AMERICAN HONDA MOTOR CO., INC.

**600 SEDAN – WHEEL SETTING (LUG) NUT TORQUE  
SPECIFICATION AND TIGHTENING PROCEDURE**

**600 SEDAN - MODIFICATION OF CYLINDER BARREL**

## 600 SEDAN AND COUPE 718A MODEL CARBURETOR

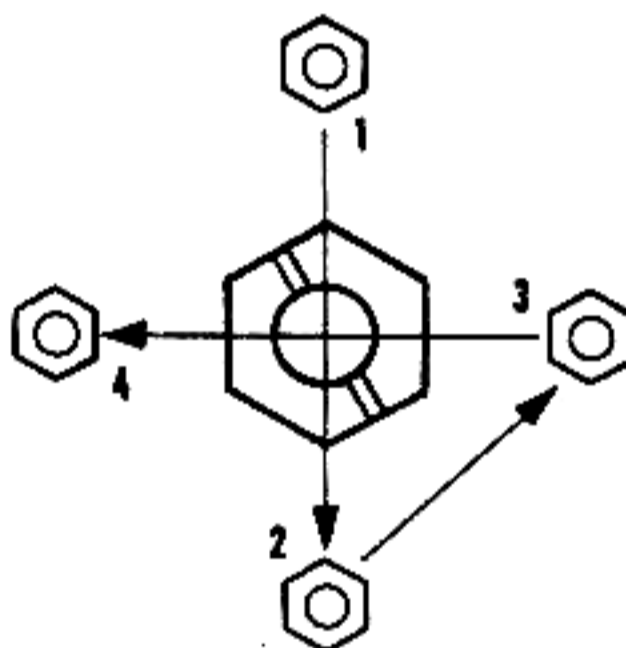
Whenever a wheel is removed and remounted, the wheel setting (lug) nuts should be tightened in the sequence shown below.

**CAUTION: DO NOT TIGHTEN THE NUTS TO MORE THAN 4.8 KgM (34.7 lb-ft)**AMERICAN HONDA MOTOR CO., INC.  
AUTOMOBILE SERVICE DEPARTMENT

TORQUE SPECIFICATION: 4.0-4.8 KgM (28.9-34.7 lb-ft)

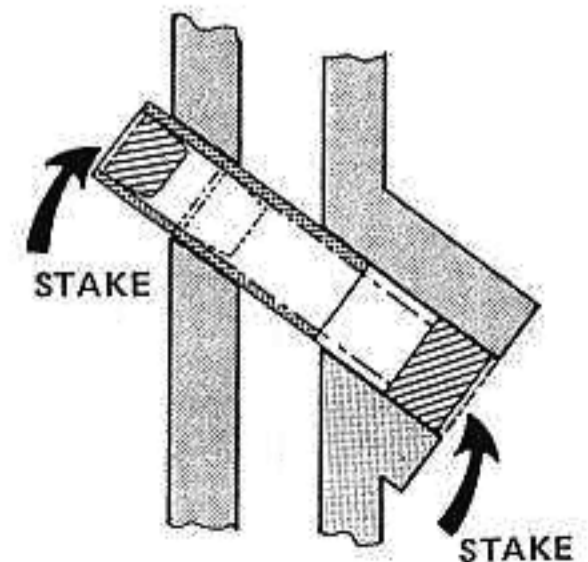
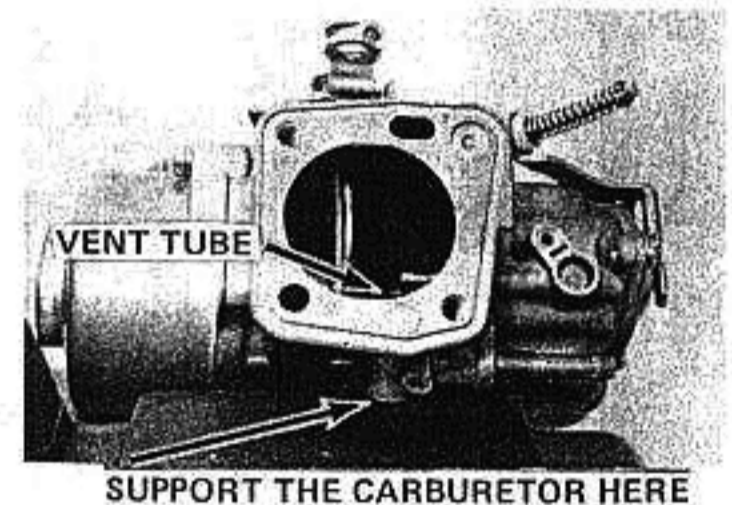
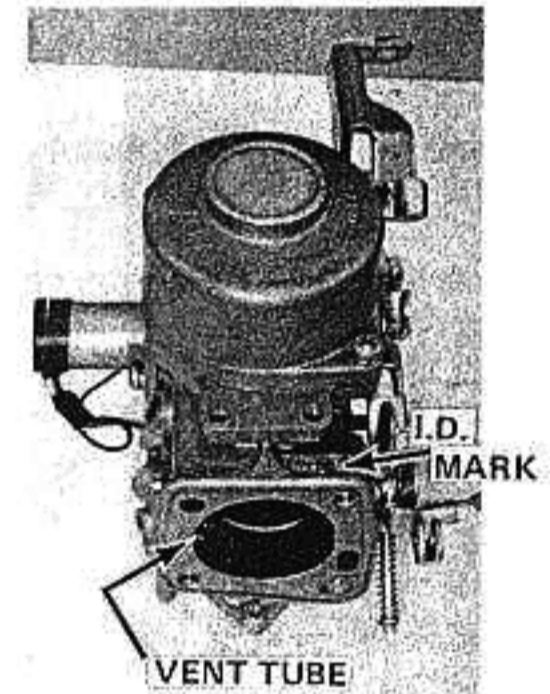
Under certain atmospheric conditions, some 600 Sedans and Coupes equipped with the 718A carburetor may experience a slight flat spot during rapid acceleration through a narrow band in the 4,000-4,500 rpm range. This condition can be corrected by installing a plug in the float chamber vent tube which extends into the left side of the choke bore and a No. 150 secondary main jet.

Remove the carburetor, then remove the carburetor air funnel and the air cleaner to carburetor bellows. Place the carburetor on a vise in such a way that the plug located on the external side of the vent is supported (see photograph). Place the small end of the plug into the vent tube and tap it in carefully with a drift punch. **DO NOT USE A CENTER PUNCH OR PIN PUNCH.** Drive the plug 0.5mm below the edge of the tube and stake the edge of the tube to secure the plug. The tube may move in as indicated in the drawing, but this will not affect carburetor performance. Turn the carburetor over and rest the air funnel mating surface on a wooden block, drive the external plug 0.5mm below the edge of the boss and stake the edge over it.

Remove the carburetor float chamber body. Remove the primary and secondary main jets by rocking the clip plate back and forth while pulling it up. Replace the secondary jet and then reinstall both jets by positioning them in the clip plate and pressing the clip plate into the carburetor. Remount the float body.

### HONDA 600 COUPE POSITIVE BATTERY CABLE INSTALLATION

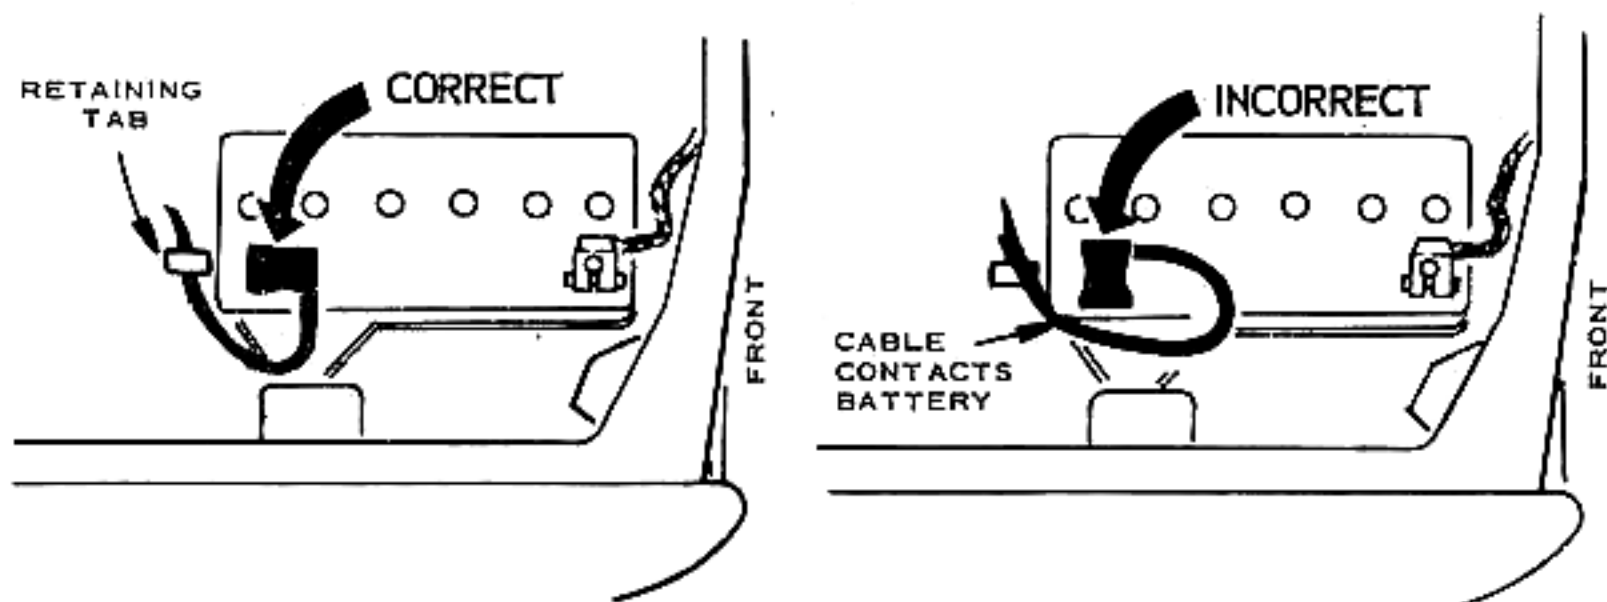
Whenever the Honda 600 Coupe's positive battery cable is disconnected, it must be remounted as shown in the illustration on the left. DO NOT mount the cable as shown on the right as it may cause it to rub against the battery case. After remounting the cable, check to be sure that it is being held away from the battery case by the retaining tab directly below the brake pipe grommet.

#### SUBJECT: HONDA 600 COUPE HOOD LATCH RELEASE CABLE

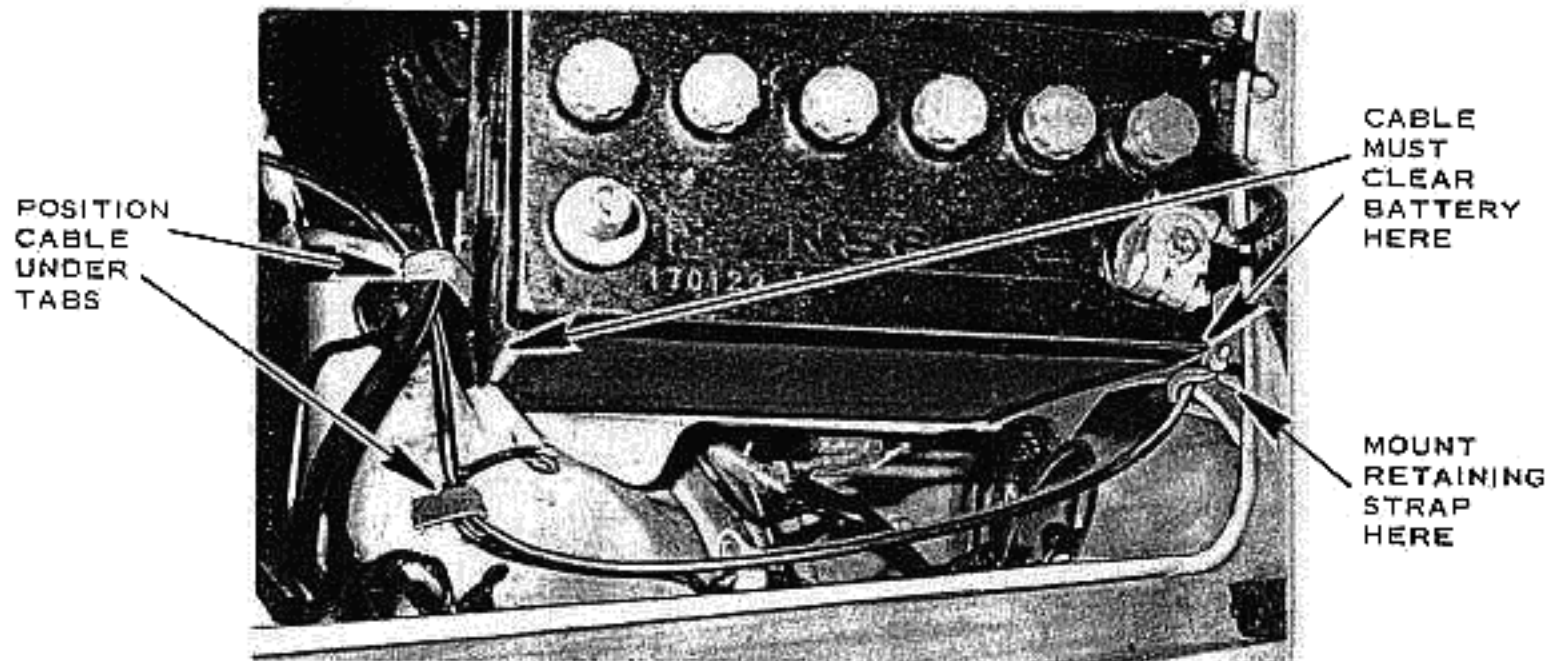
The Honda 600 Coupe hood latch release cable housing may rub against and damage the right front and rear corners of the battery. This condition can be prevented by the installation of a retaining strap to hold the cable away from the front edge of the battery case and by routing the cable through the retainer tabs in the engine compartment as shown in the photograph.

The hood latch release cable retaining strap must be installed and the cable must be routed under the tabs on all Honda 600 Coupes in your stock. All 600 Coupe Owners will be notified by mail to return to their dealers to have these services performed free of charge.

**LOOSE GROUND CONNECTION  
600 SEDAN AND COUPE**

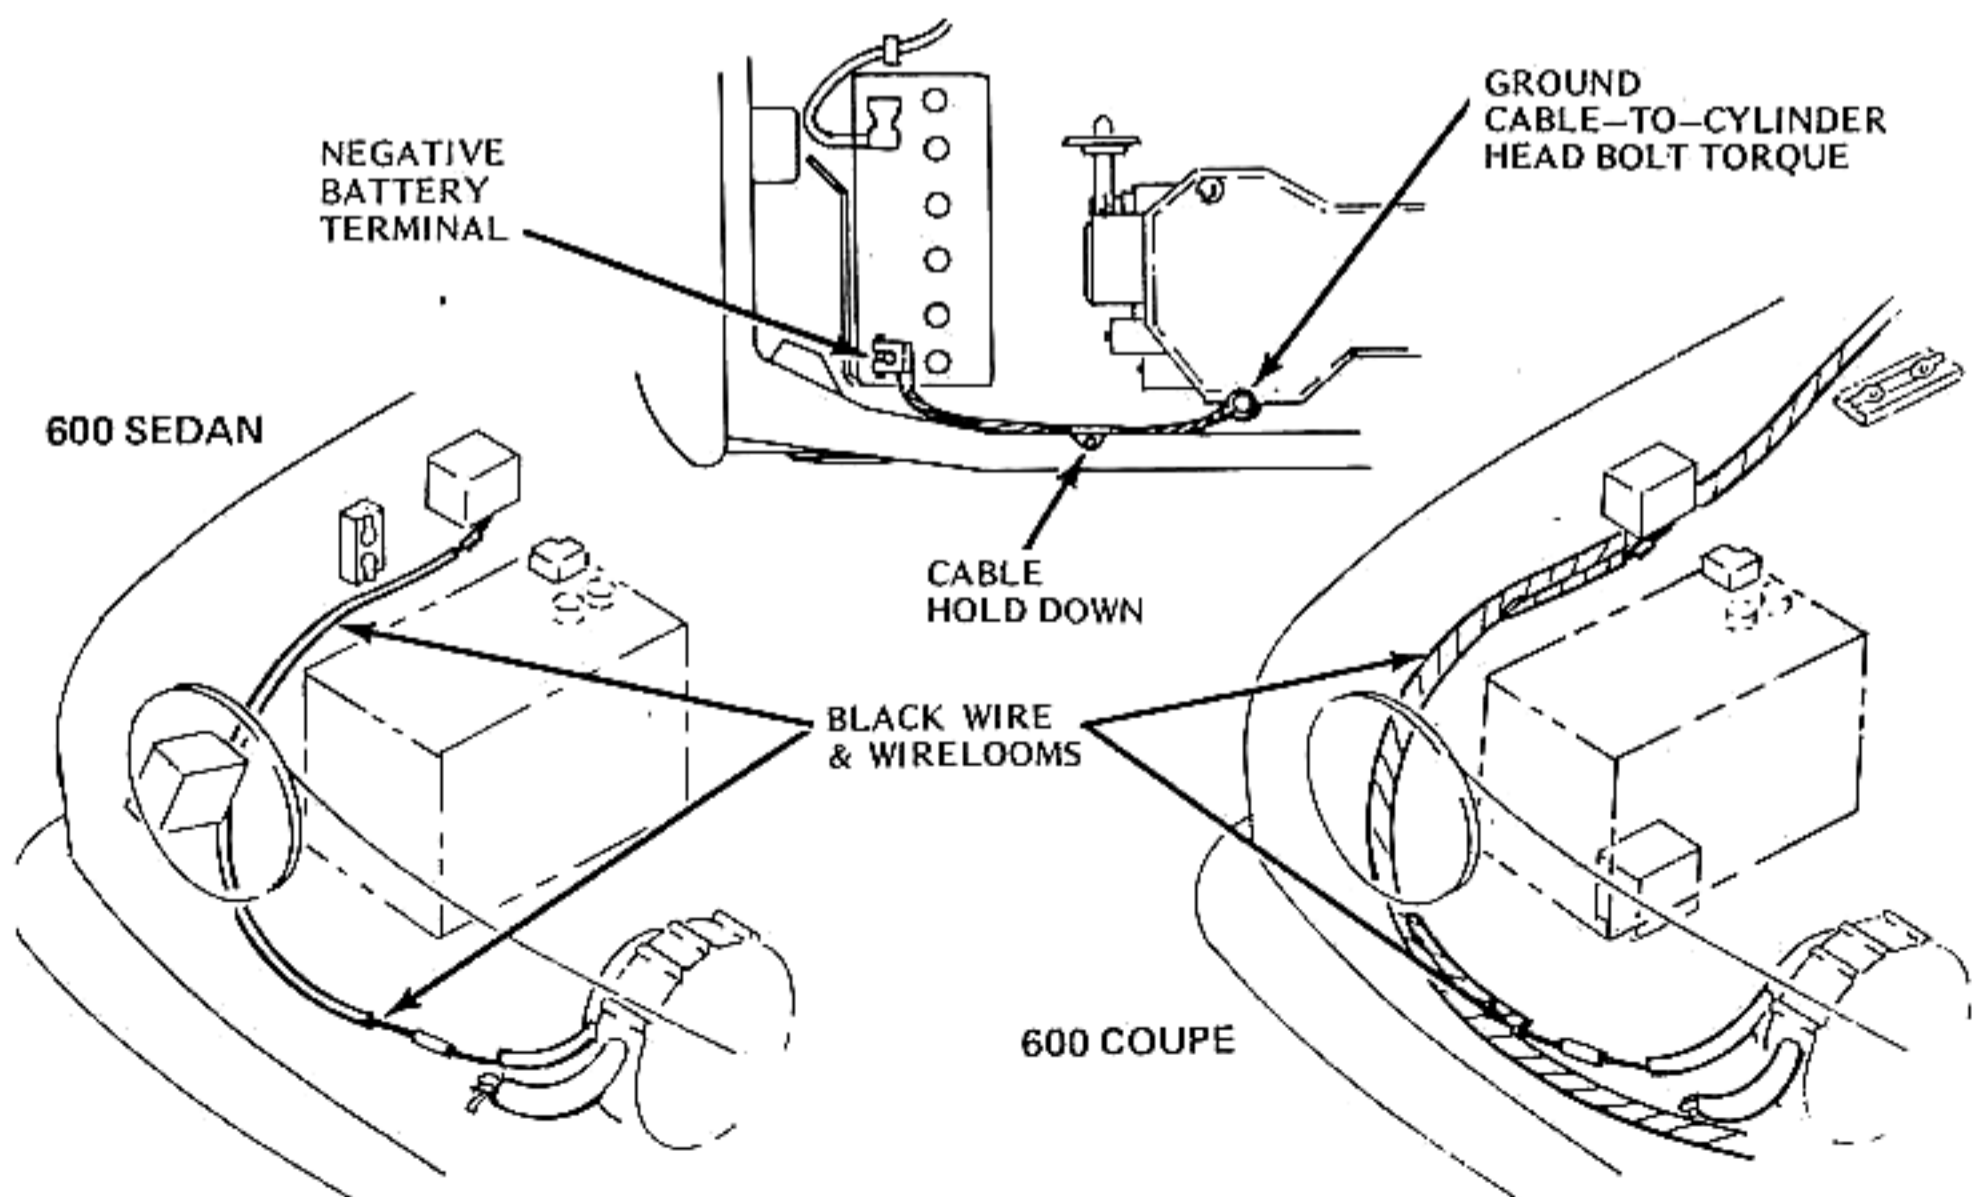
**SYMPTOMS:** Overheating or burning of the ground wire (black) from the voltage regulator to the alternator.

**DIAGNOSIS:** If the ground connection on the cylinder head is loose, the current that would normally flow through this cable is diverted through the black wire connecting the voltage regulator to the alternator. This wire is not designed to carry the heavy current loads and it will overheat. Damage to parts other than the ground wire (black) or its loom is unlikely but replacement of the wire may require a new set of alternator brushes and/or a new voltage regulator.

**CORRECTIVE ACTION:** The ground cables on all cars should be checked during routine servicing. Check for a loose ground cable-to-cylinder head bolt and check the cable for broken or frayed strands.

**GROUND CABLE TO ENGINE BOLT  
1.0-1.4 Kg-M (7-10 ft/lbs.)**

**OVERHEATING OF CHARGE INDICATOR RELAY  
600 SEDAN AND COUPE**

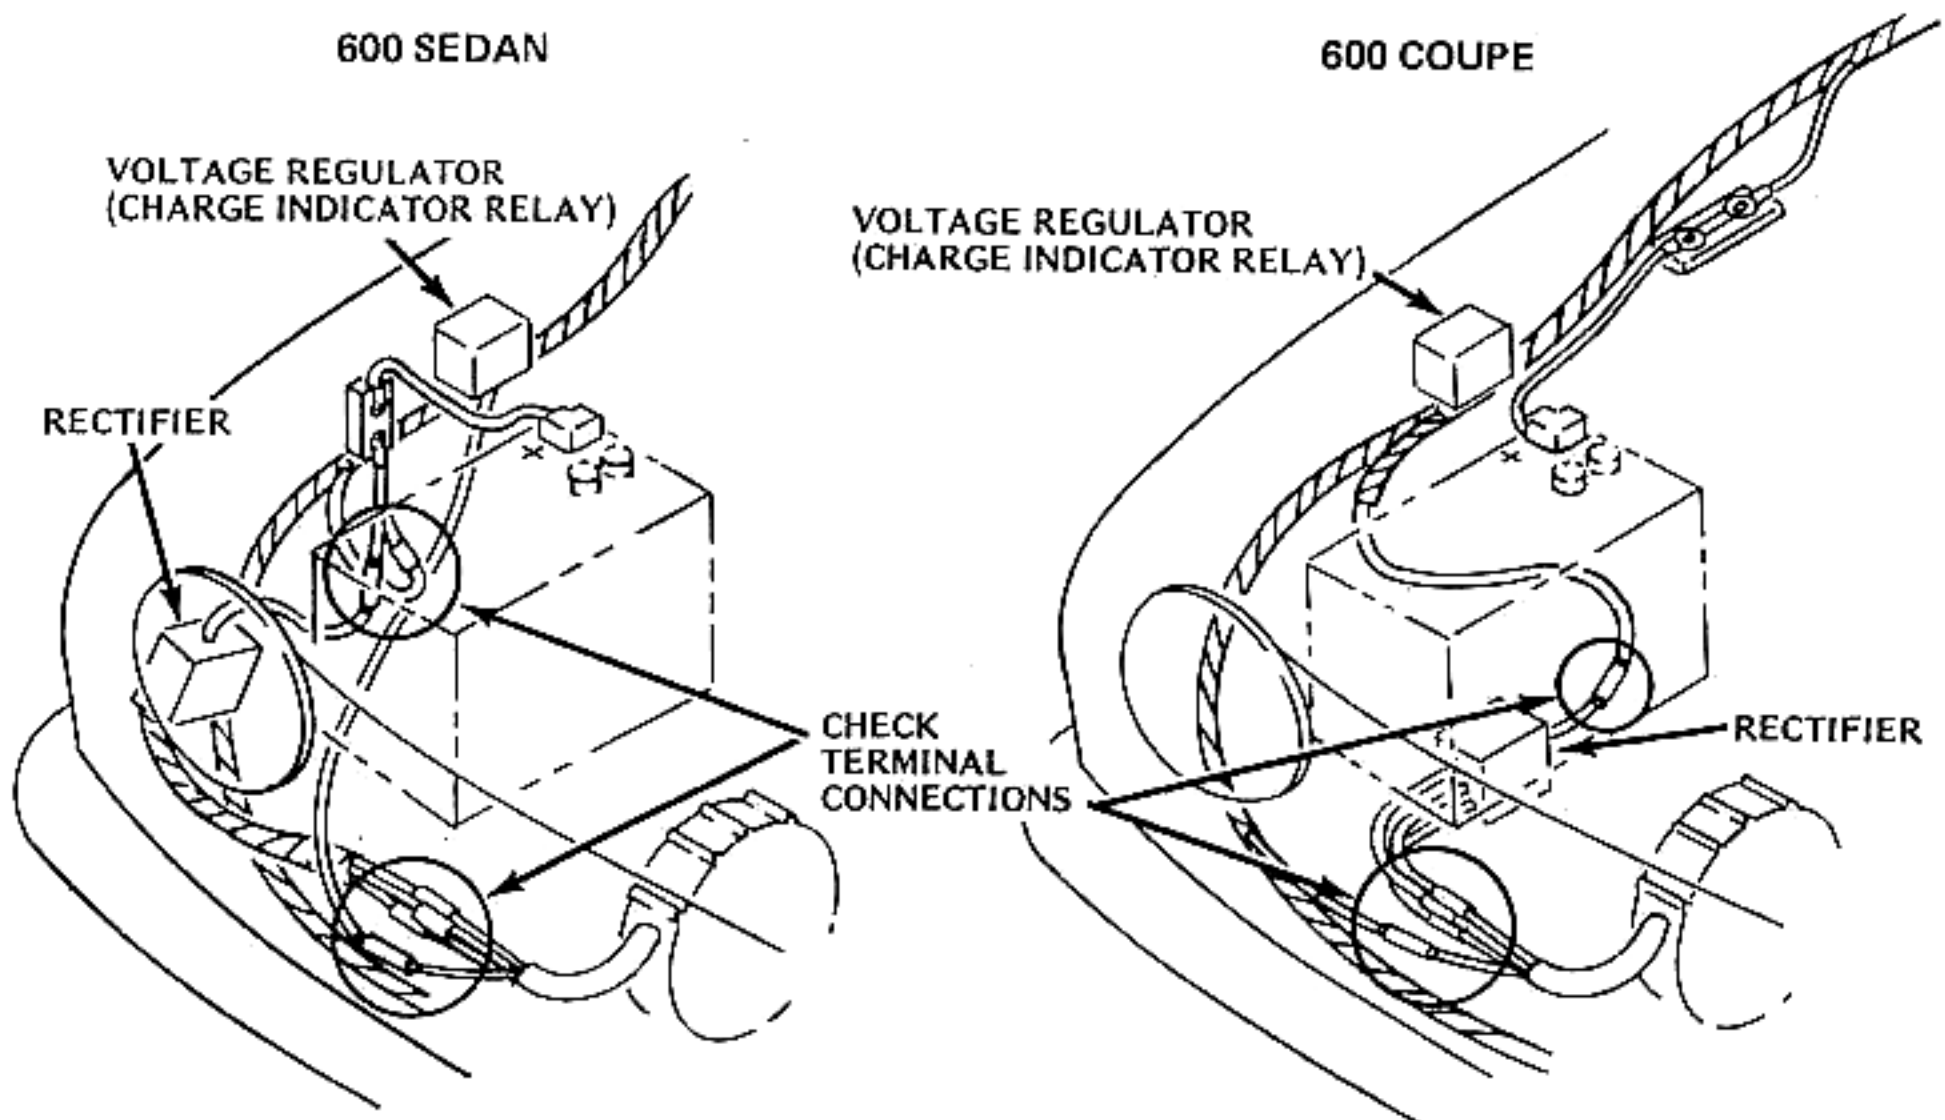
**SYMPTOMS:** Discoloration and possible melting of the charge indicator relay in the voltage regulator.

**DIAGNOSIS:** A poor connection at the rectifier output wire terminal will reduce current through the rectifier. This forces additional current through the wire (W/BL) between the stator and the voltage regulator and overheats the voltage regulator (charge indicator relay).

- Check the rectifier output wire terminal and the rectifier input terminals for loose or damaged connections.
- Start the engine and see if the charge indicator light goes out. If not, check the operation of the charge indicator relay.
- Check the amperage output and the no-load voltage to determine overall condition of charging system.

**REPLACEMENT OF LOW/SECOND SHIFT GEAR  
 AND MAINSHAFT THIRD GEAR  
 (HONDA 600 SEDAN NON-SYNCHRONIZED TRANSMISSION ONLY)**

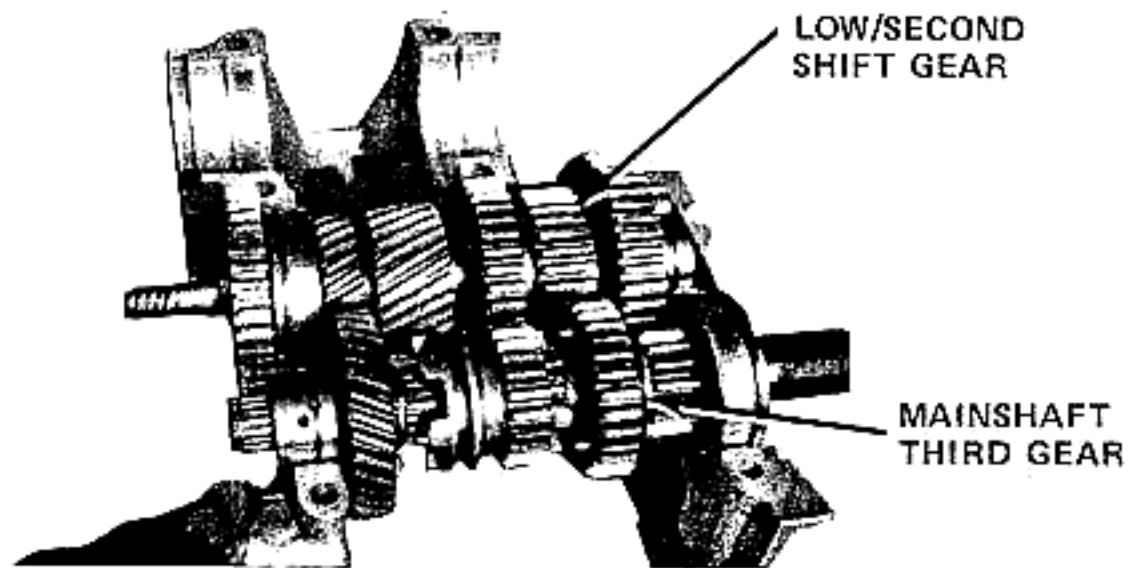
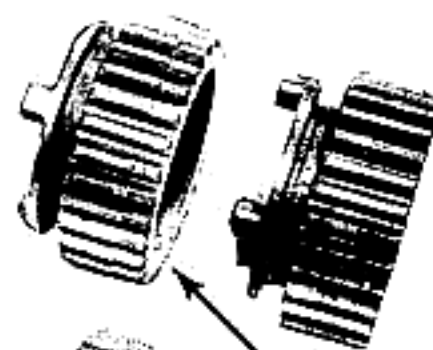
When replacing one or both of the above mentioned gears, they should be carefully inspected as outlined in this bulletin. There are two low/second shift gears and two mainshaft third gears available. Certain combinations of these gears will not mesh with each other because their diameters are different. If one or both of these gears is to be replaced, they should be carefully measured and compared with the specifications below before ordering replacement parts.

LOW/SECOND SHIFT  
 PN 23441-551-060  
 (DIA. 63.2MM)

MAINSHAFT THIRD GEAR  
 PN 23470-568-030  
 (DIA. 64.6MM)

LOW/SECOND SHIFT GEAR  
 PN 23441-551-040  
 (DIA. 64MM)

MAINSHAFT THIRD GEAR  
 PN 23470-568-020  
 (DIA. 64.1MM)
